South Texas Project Electric Generating Station P.O. Box 289 Wadsworth, Texas 77483

December 09, 2009
NOC-AE-09002491
File No.: G25
10CFR50.55a

South Texas Project
Unit 2
Docket No. STN 50-499
Amended Request for Relief from ASME Boiler and Pressure Vessel Code
Section XI Requirements for the Essential Cooling Water System
(Relief Request RR-ENG-2-52) (TAC ME0899)

**RELIEF REQUEST RR-ENG-2-52:
RESPONSE TO REQUEST FOR ADDITIONAL INFORMATION**

Figure 1

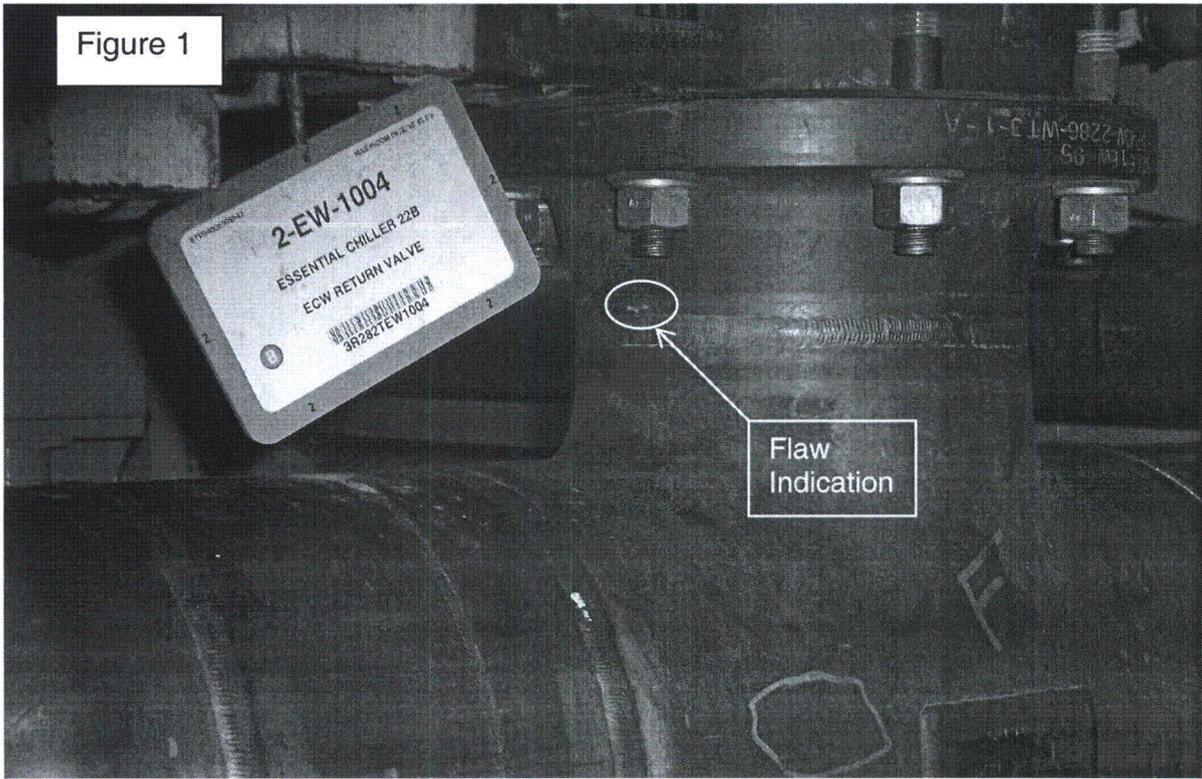
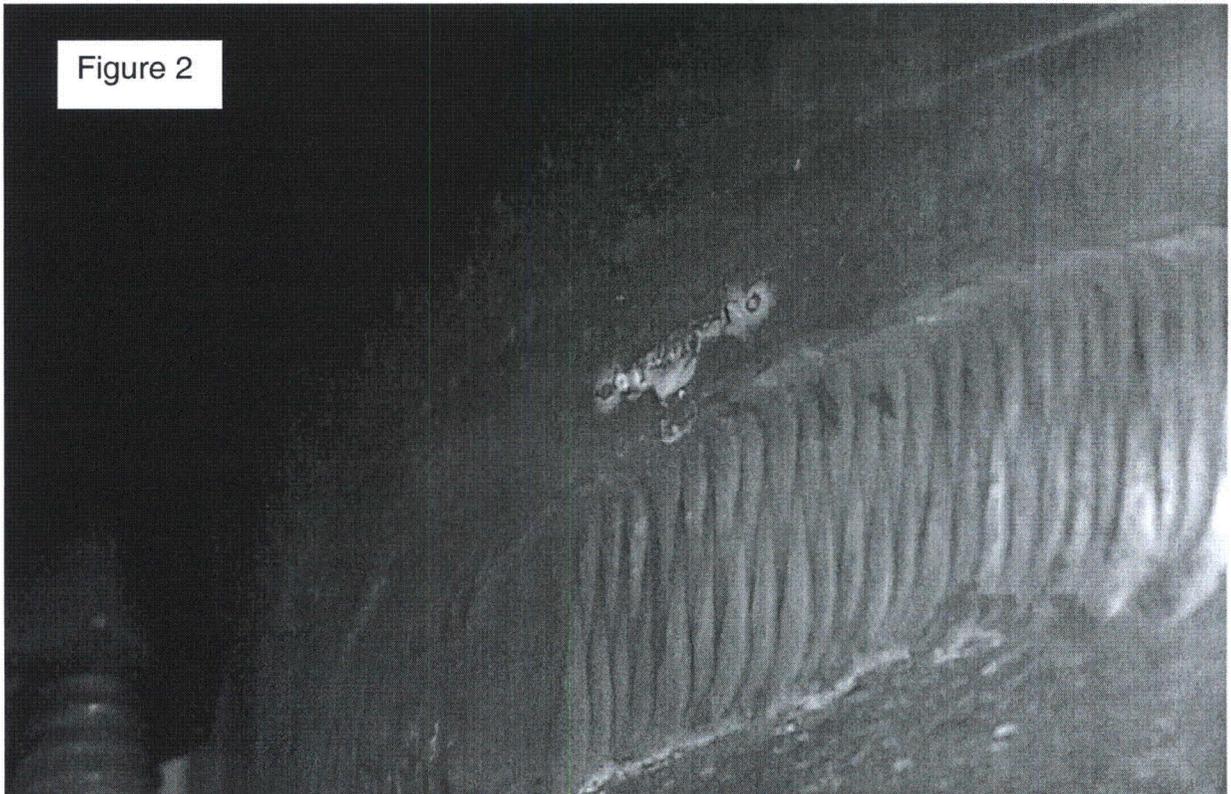
- 2(d) Discuss whether the flaw is in the circumferential or axial direction.

An indication of a through-wall flaw was found on the downstream flange of Essential Chiller 22B ECW return throttle valve 2-EW-1004. Leakage residue buildup in a line parallel to the circumferential weld was found at the weld on the downstream flange of the valve, with an underlying flaw of approximately 3/8-inch in length. The flaw appears to be a tight crack as leakage is not readily measurable. The attached pictures show the location (Figure 1) and the appearance (Figure 2) of the residue buildup. Nominal pipe diameter is 8 inches, with a pipe wall thickness of 0.322 inch.

The circumferential orientation of the flaw can be seen in Figures 1 and 2. The circumferential orientation is also stated in paragraph 1(d) of the original submittal.
